LAST REVISION 11/01/17	DESCRIPTION:	FDOT	FY 2023-24 STANDARD PLANS	MAILBOXES	INDEX 110-200	SHEET 2 of 3
---------------------------	--------------	------	------------------------------	-----------	------------------	-----------------

FLANGED CHANNEL

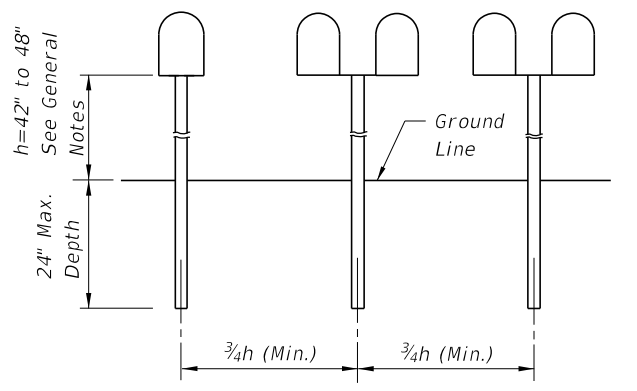
Corrected missing callout
